MEMORANDUM

UTAH DEPARTMENT OF TRANSPORTATION

SUBJECT: Standards Committee Meeting Minutes and Next Meeting

TRAFFIC CONTROL
EXIT RAMP GORE

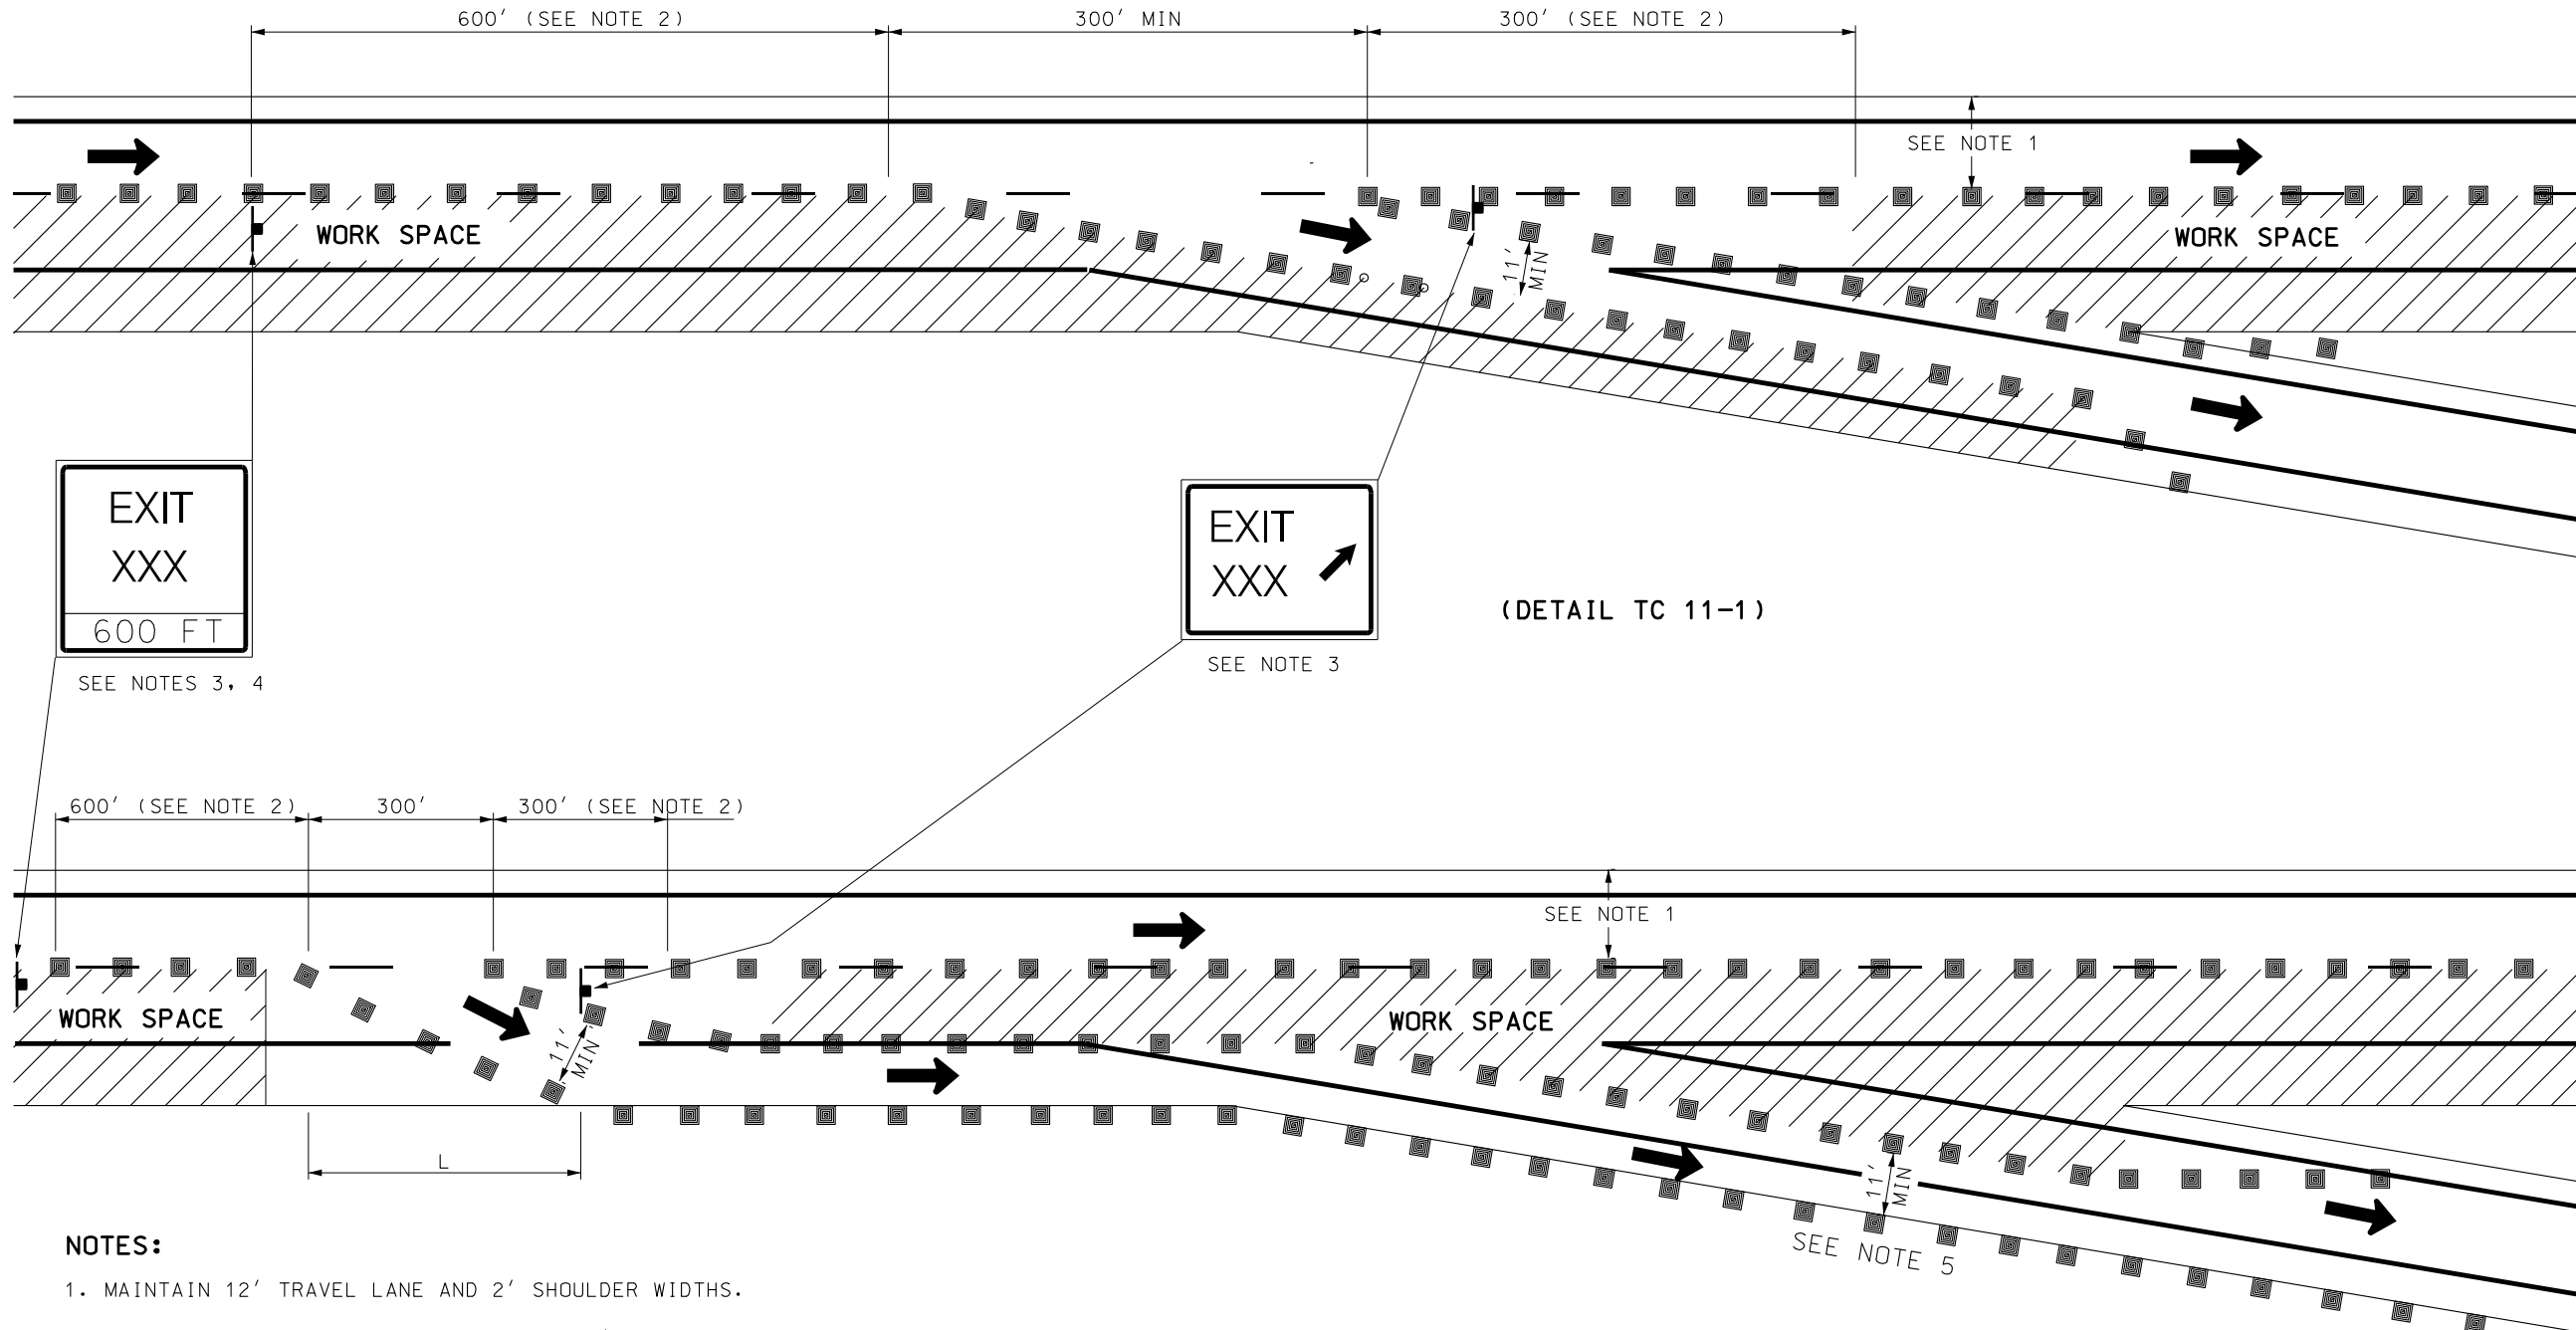
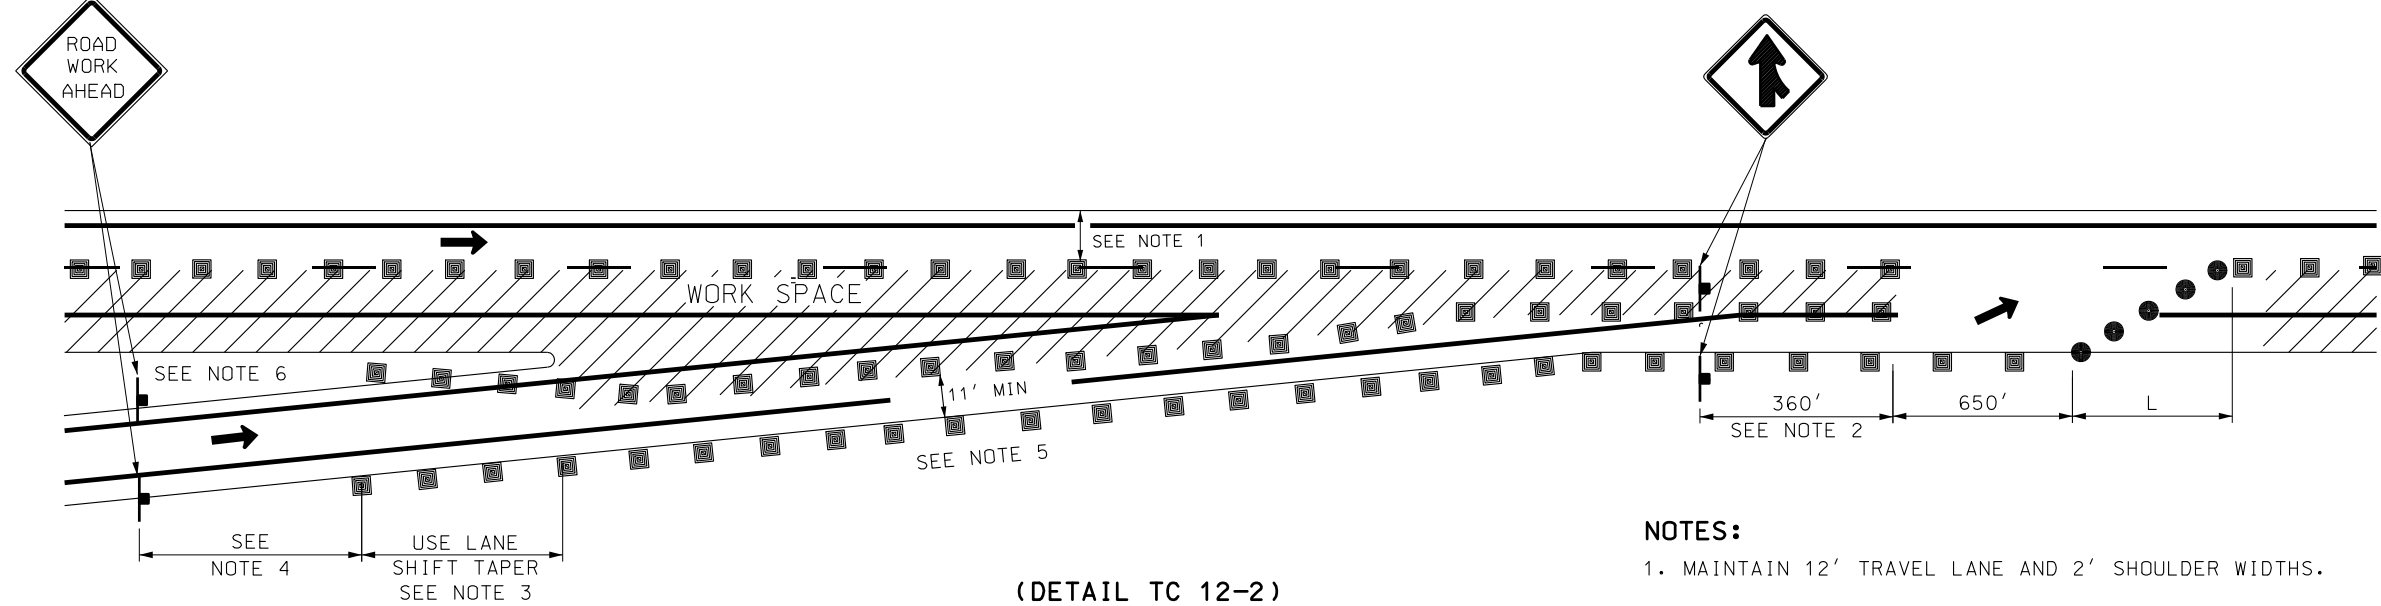
1. Changed icons for channelization devices and direction of travel to match common usage.
2. Cleaned up sheet details for readability
3. Added Note 4 not requiring channelizing devices when right shoulder pavement width is adequate
4. Changed taper on exit ramp from L/2 to L to match MUTCD requirements on Detail TC11-2
5. Removed dimension of 400' on exit ramp.

FLAGGING OPERATION - ONE WAY
WITH POTENTIAL ENCROACHMENT
BY WORK VEHICLE
(DETAIL TC 14-1)

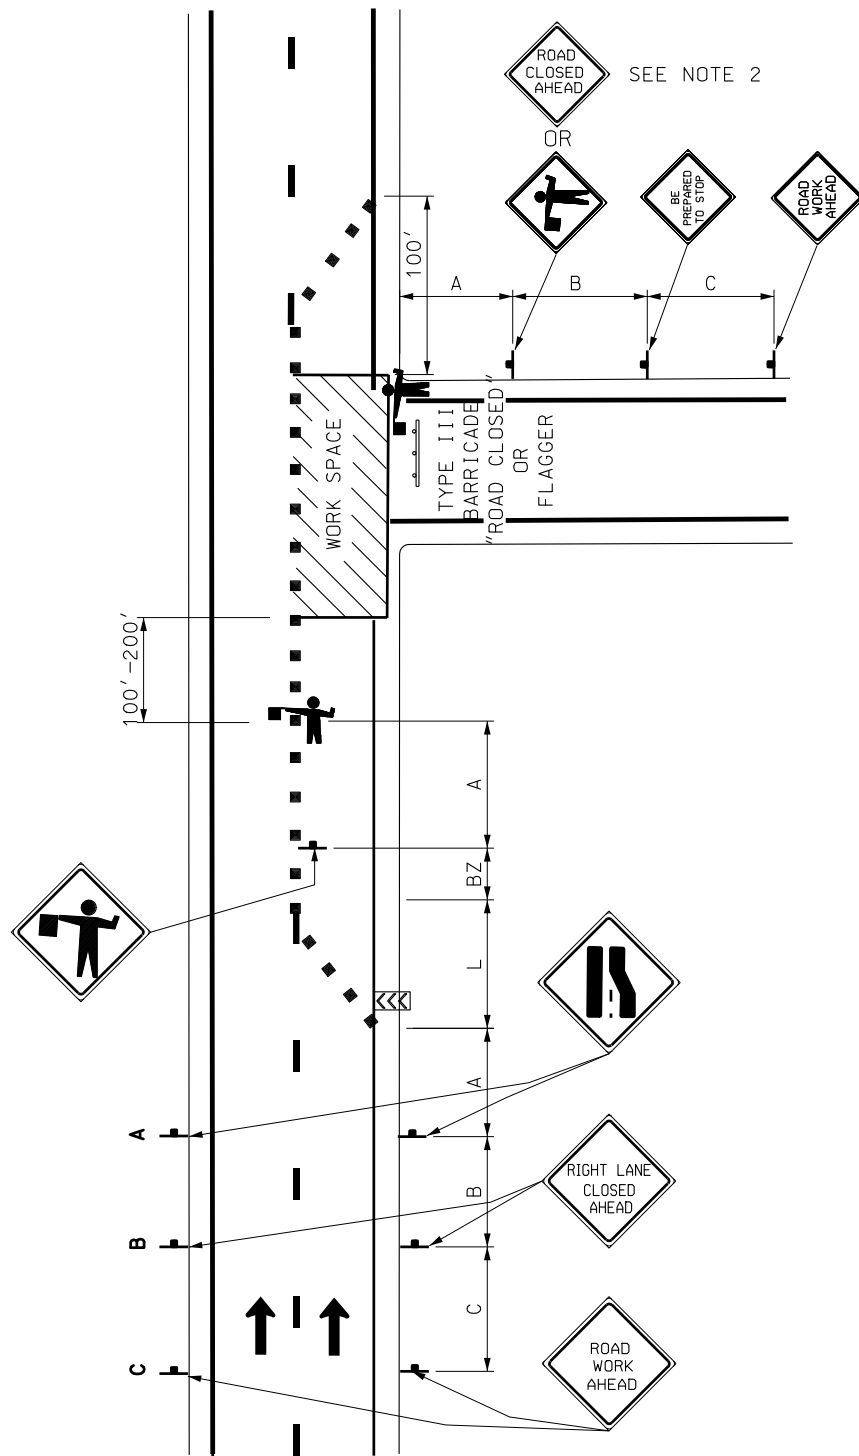
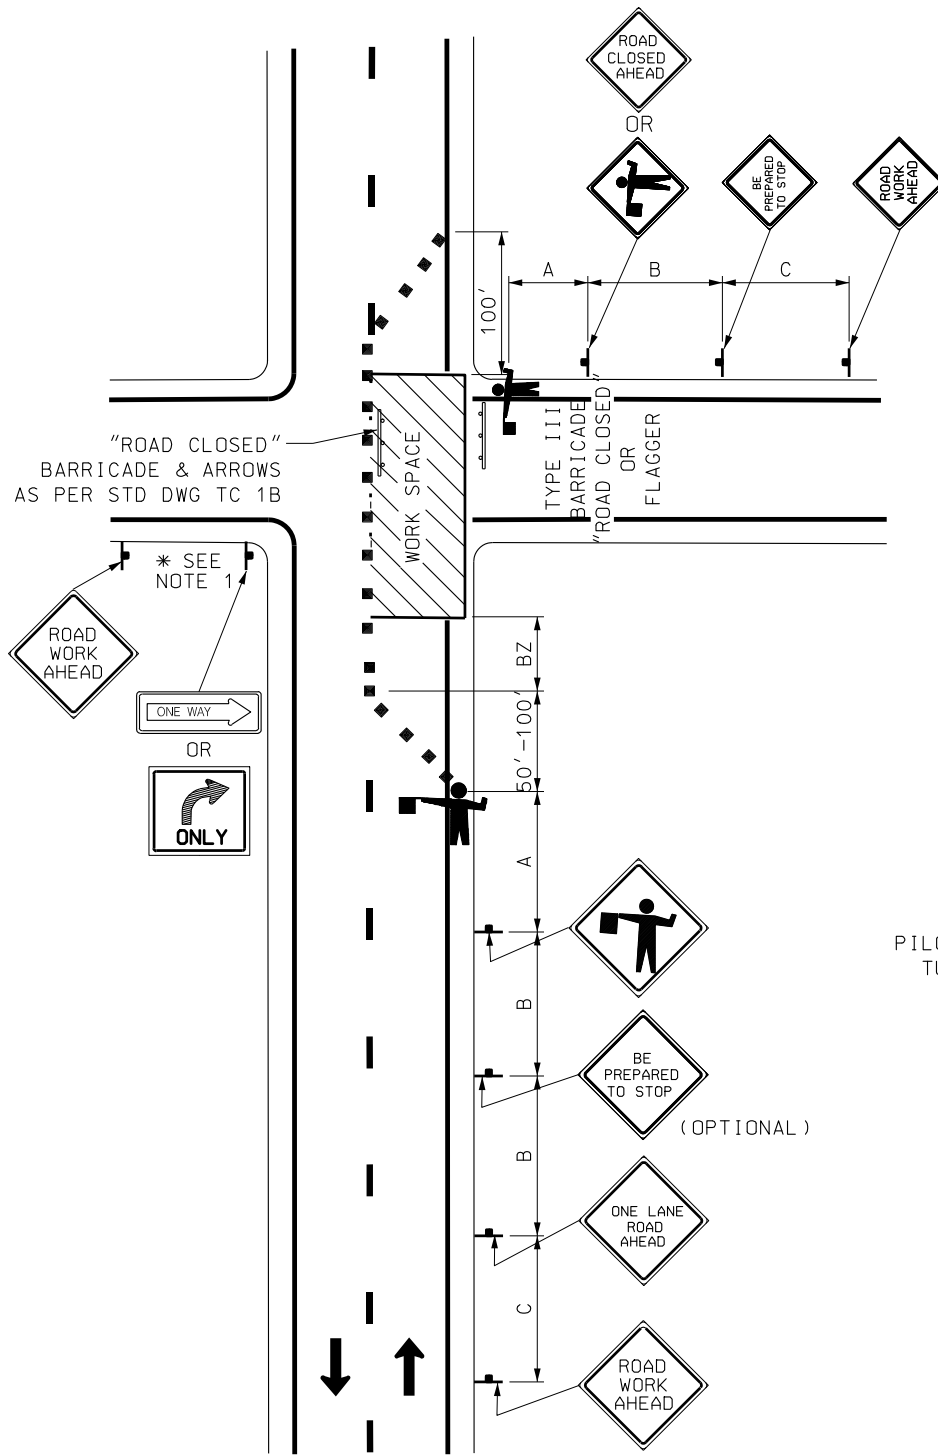
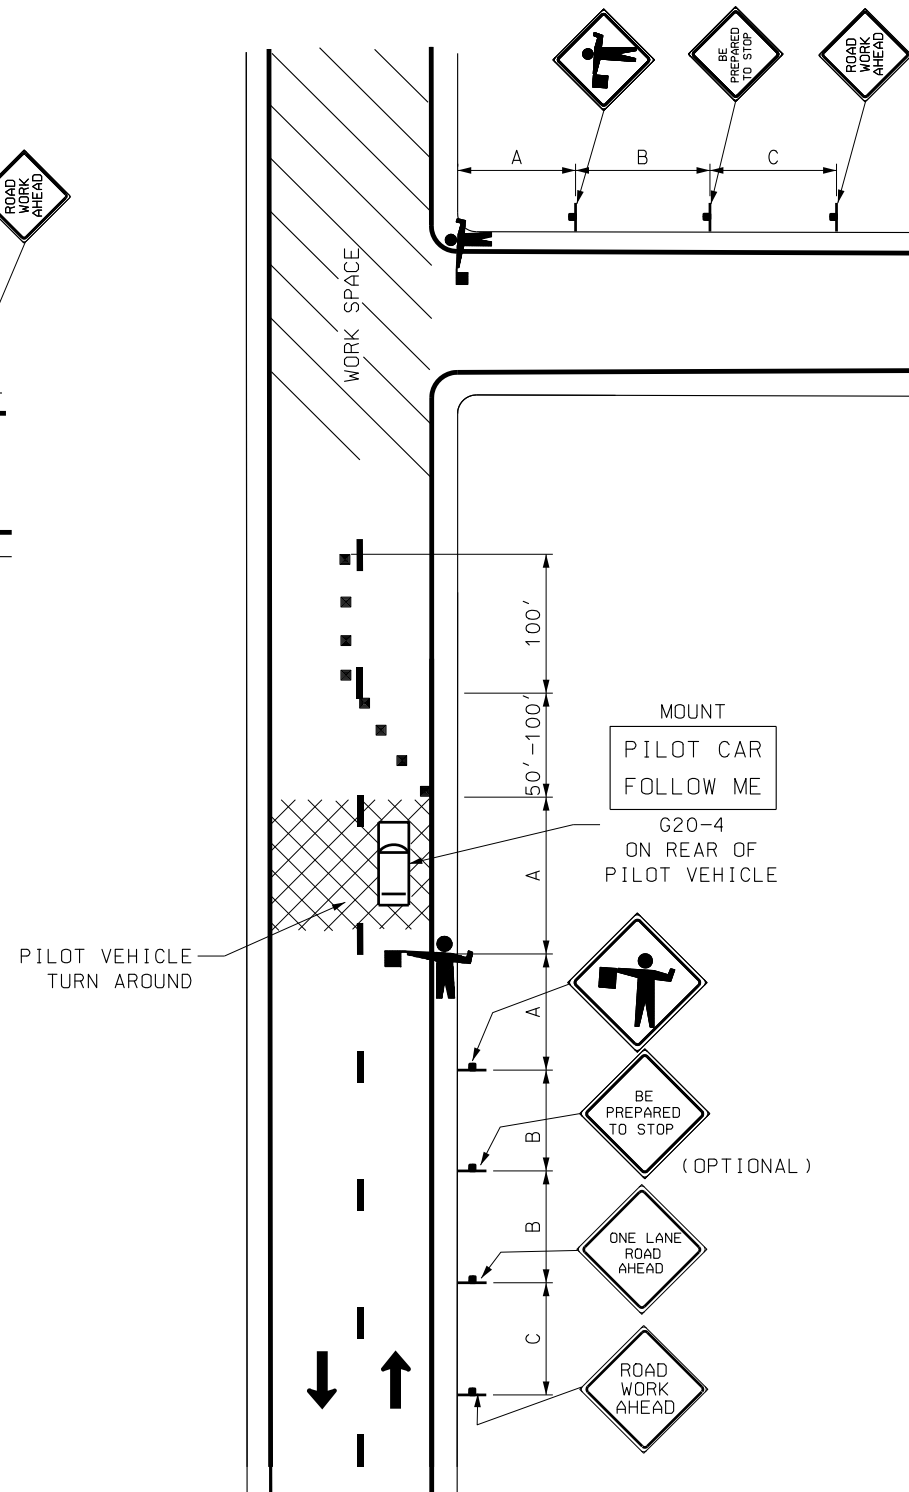
1. Changed icons for channelization devices and direction of travel to match common usage.
2. Revised signs to match the current MUTCD.
3. Added Note on Project Limit signing
4. Added One-Way sign on Detail 14-2
5. Added 'Pilot Car Follow Me' detail to Detail 14-3
6. Clarified location of flaggers on side street all Details
7. Placed signs on Detail 14-1 for uniformity of details
8. Modified Arrow Panel location
9. 'Be Prepared to Stop' sign made optional
